| Well Name: JAMES RANCH UNIT DI 2 | Well Location: T22S / R30E / SEC 25 / NESW / 32.362357 / -103.83695 | County or Parish/State: EDDY / NM |
| US Well Number: 3001545400 | Well Status: Approved Application for Permit to Drill | Operator: XTO PERMIAN OPERATING LLC |

Notice of Intent

Procedure Description: **Well Name, SHL Change, Spacing, Casing/Cement, Drilling Variance Changes XTO Permian Operating, LLC requests permission to make the following changes to the original APD: Change well name fr/James Ranch Unit DI 2 BS2A-5W 226H to James Ranch Unit DI 2 706H No Additional Surface Disturbance Change SHL fr/2370'FSL & 1850'FWL to 2500'FSL & 2020'FWL. Total SHL Move: 130' South & 170' West SHL change requested to optimize drill island space and for safety purposes. Change BHL fr/1980'FSL & 2440'FEL to 1980'FSL &2590'FEL Casing/Cement design per the attached drilling program. XTO also requests the following variances: Approval to utilize a spudder rig to pre-set surface casing per the attached description of operations. Batch drill this well if necessary. In doing so, XTO will set each casing string and ensure that the well is cemented properly and the well is static. With floats ho

BOPCO, LP
5000# BOP

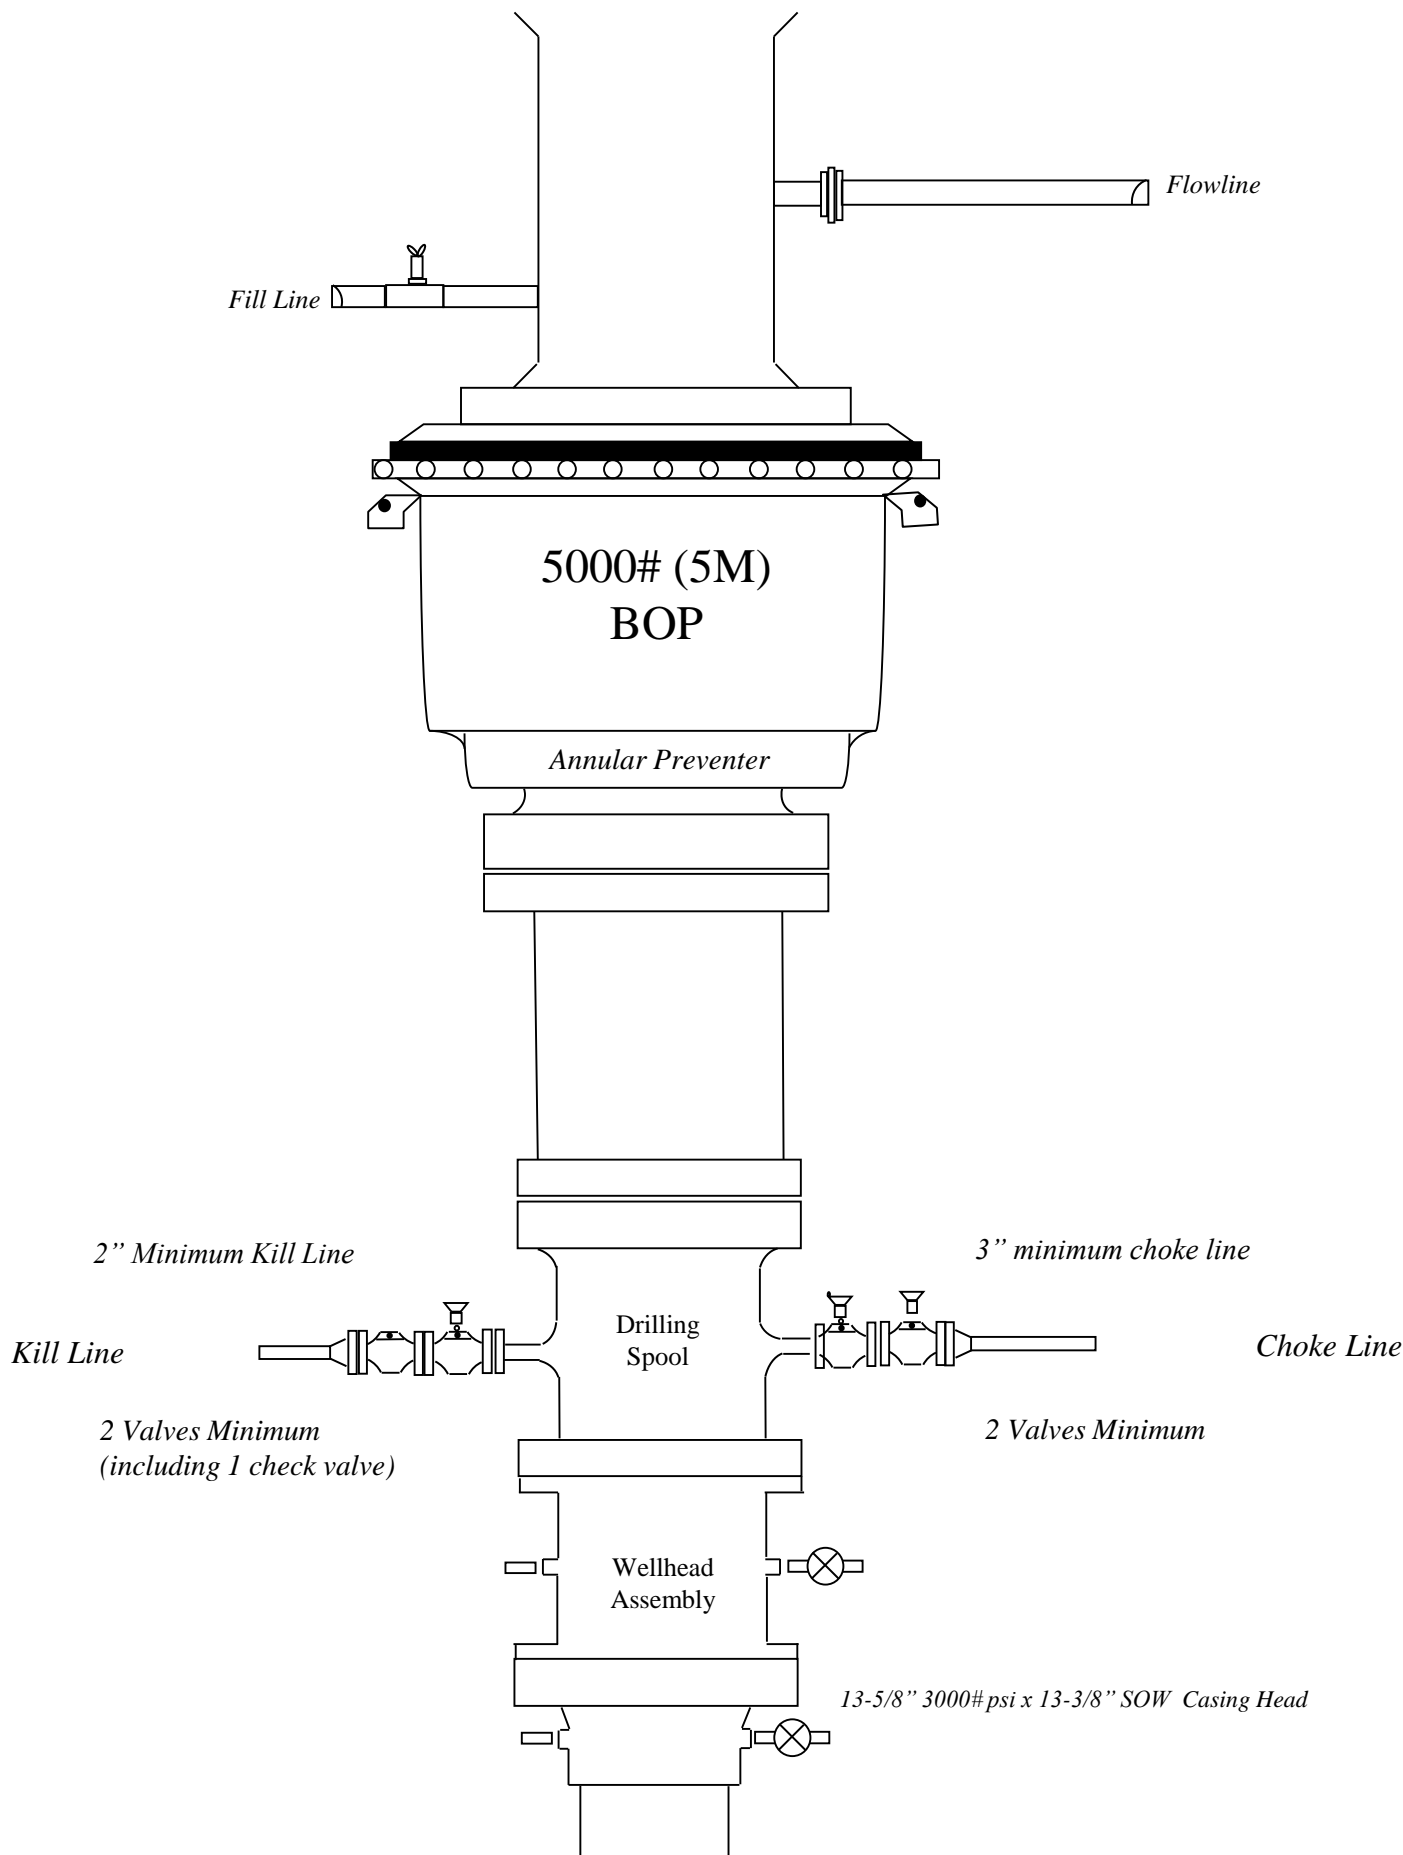
A variance is requested to allow use of a flex hose as the choke line from the BOP to the Choke Manifold. If this hose is used, a copy of the manufacturer's certification and pressure test chart will be kept on the rig. Attached is an example of a certification and pressure test chart. The manufacturer does not require anchors.

Wellhead diagram during skidding operations

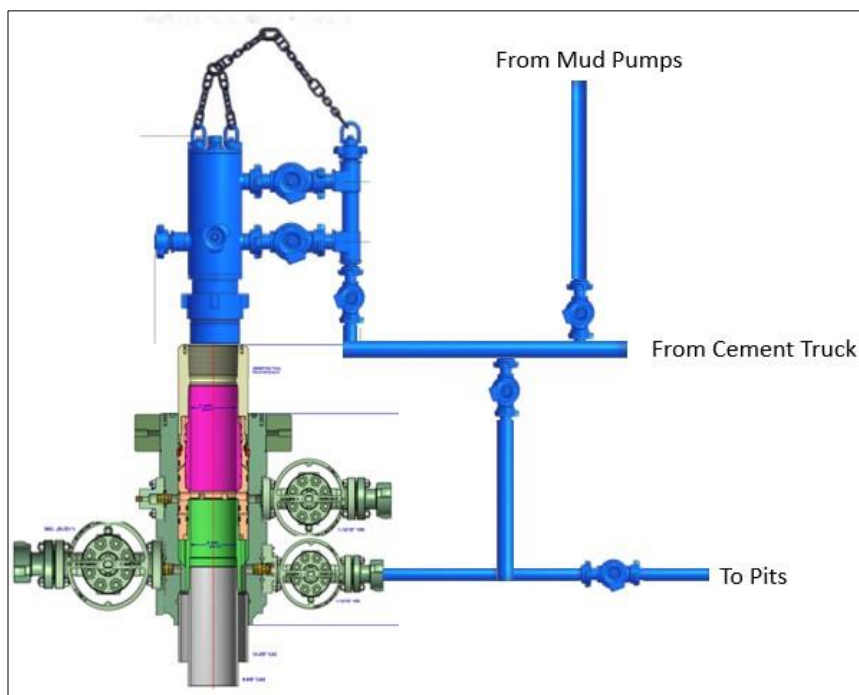
6. Skid rig to next well on pad.
7. Confirm well is static before removing cap flange, flange will not be removed and offline cementing operations will not commence until well is under control. If well is not static, casing outlet valves will provide access to both the casing ID and annulus. Rig or third party pump truck will kill well prior to cementing or nipping up for further remediation.
